## **Proposal for the 10 series of amendments to UN Regulation No. 17 (Strength of seats)**

The text reproduced below was prepared by the expert from CLEPA aimed to amend the proposal of 10 series of amendments to UN Regulation No. 17 from Japan ECE/TRANS/WP.29/GRSP/2019/27. This document updates formal document ECE/TRANS/WP.29/GRSP/2019/9 from Clepa. The modifications to the text of the UN Regulation are marked in bold for new or strikethrough for deleted characters.

**"Figure 8-3  
Portion of gap above 540mm**

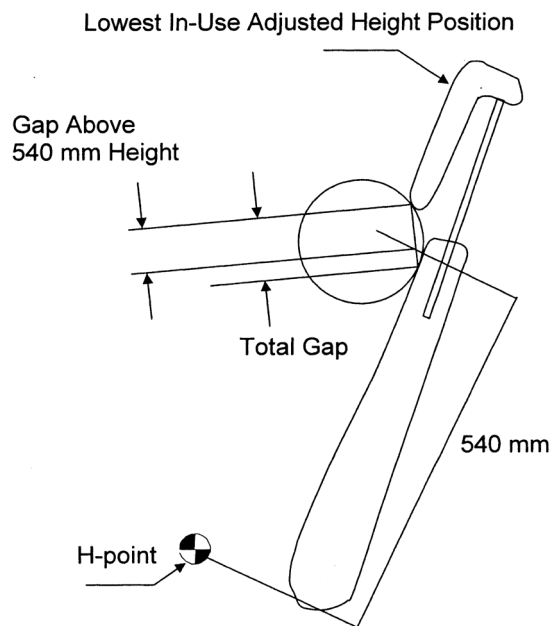
Annex 8, paragraph 2.3., amend to read:

- "2.3. The area of measurement is anywhere between two vertical longitudinal planes passing at 85 mm on either side of the torso line and above ~~the top of the seat back~~ **a height greater than 540 mm.**"

- "2.5. Determine the gap dimension by measuring the straight line distance between the inner edges of the two furthest contact points, as shown in Figures 8-1, ~~and 8-2 and 8-3.~~"

Annex 8, insert new Figure 8-3, to read:

3. In addition, the gap measurement procedure by the sphere was modified in the Federal Motor Vehicle Safety Standard 202a to consider only gaps in the area over 540 mm. This proposal adds the proposed area where the gap is considered for the sphere method.
